THE MARYLAND-NATIONAL CAPITAL PARK AND PLANNING COMMISSION

MEMORANDUM

PROJECT NAME: Mitter Property

CASE #: 1-05051

PRELIMINARY PLAN
MITTER PROPERTY
 Montgomery County, Maryland

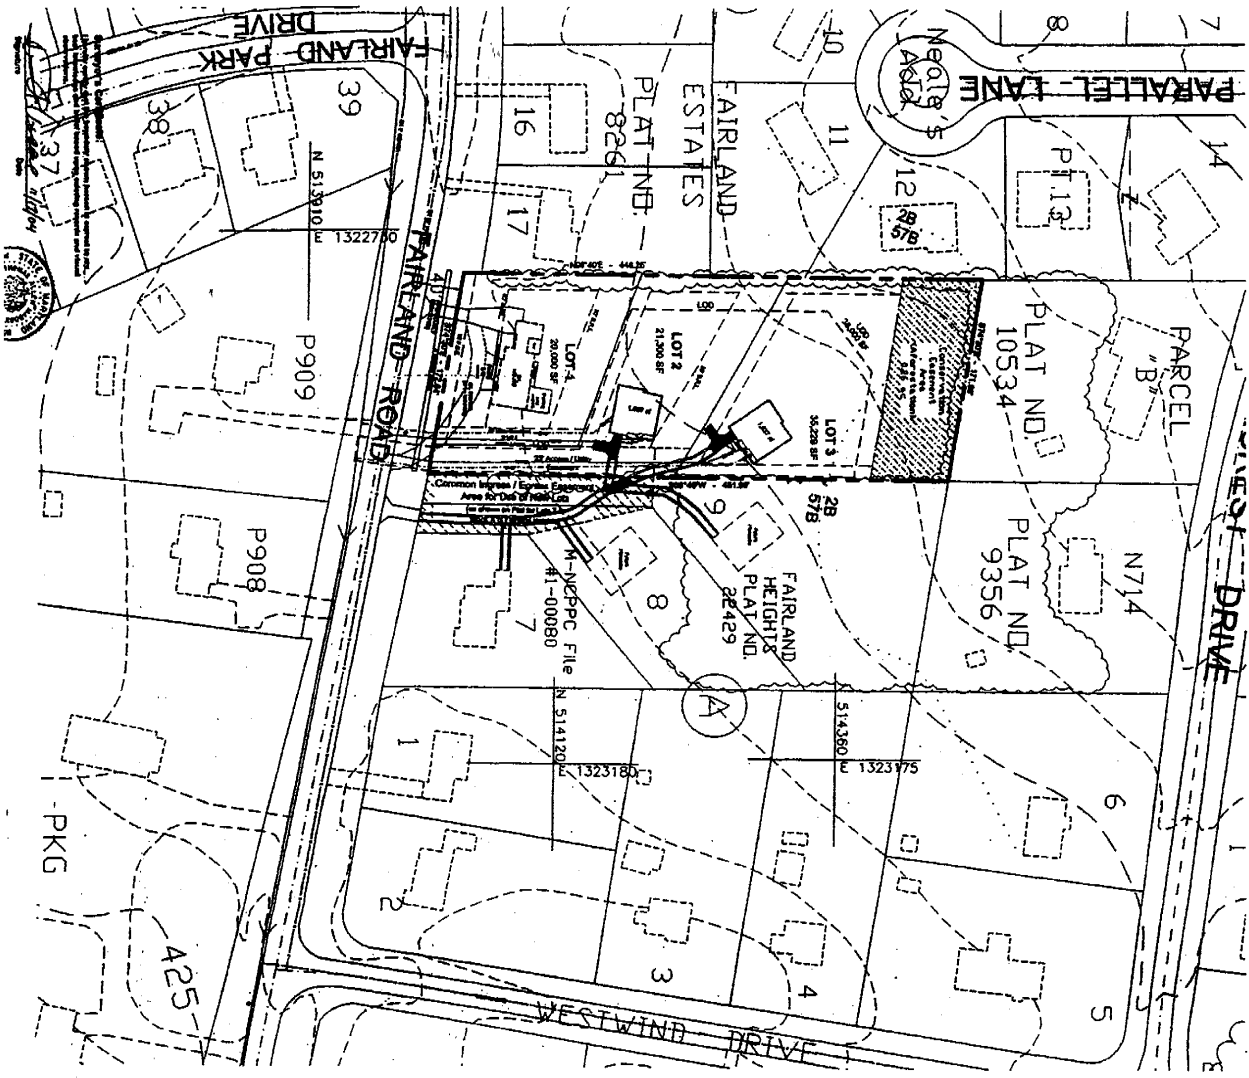
The Upper Paint Branch SPA has a ten percent (10%) site imperviousness limit on development. The imperviousness limit is set forth in the environmental overlay zone for the Upper Paint Branch SPA. The water quality plan proposes a site imperviousness of 10 percent. This consists of two new houses drive strips for the new houses (each with a footprint of no more than 1458 square feet), and one existing house and driveway. Portions of the existing driveway will be removed so that the subdivision does not exceed the 10 percent imperviousness limit. The site imperviousness also includes a four-foot sidewalk along Fairland Road that is to be constructed as part of the subdivision. The applicant's proposal conforms to the environmental overlay zone.

The Upper Paint Branch SPA has a ten percent (10%) site imperviousness limit on development. The imperviousness limit is set forth in the environmental overlay zone for the Upper Paint Branch SPA. The water quality plan proposes a site imperviousness of 10 percent. This consists of two new houses drivestrips for the new houses (each with

a footprint of no more than 1458 square feet), and one existing house and driveway. Portions of the existing driveway will be removed so that the subdivision does not exceed the 10 percent imperviousness limit. The site imperviousness also includes a four-foot sidewalk along Fairland Road that is to be constructed as part of the subdivision. Staff recommends that the preliminary plan The applicant's proposal conforms to the environmental overlay zone.

There is no existing forest on the site. To meet the forest conservation requirements, 0.26 acre of afforestation is proposed at the rear of proposed Lot 3. Staff believes this is acceptable. In addition, staff recommends that the final forest conservation plan include a detailed tree protection plan to provide appropriate protection measures during construction for the large trees that will be retained on the site.

1. Prior to record plat, applicant to enter into an agreement with the Planning Board to limit impervious surfaces to no more than 10 percent as shown on the revised preliminary plan.

2. Prior to release of building permits, applicant to demonstrate conformance to impervious surface limits as shown on the revised preliminary plan. Any modifications to these plans which increase site imperviousness may require Planning Board action.

- a. Final forest conservation plan to include a detailed planting plan for the 0.26 acre of afforestation on the site. Afforestation area to be placed in a Category I conservation easement. Easement to be shown on the record plat.

- b. Final forest conservation plan to include tree protection measures for trees on the site that are to be retained.

- c. Final forest conservation plan to include methods to clearly mark the Category I conservation easement boundary, such as a permanent split rail fence.
5. Conformance to the conditions as stated in DPS' water quality plan approval letter dated February 28, 2005 (Attachment A).
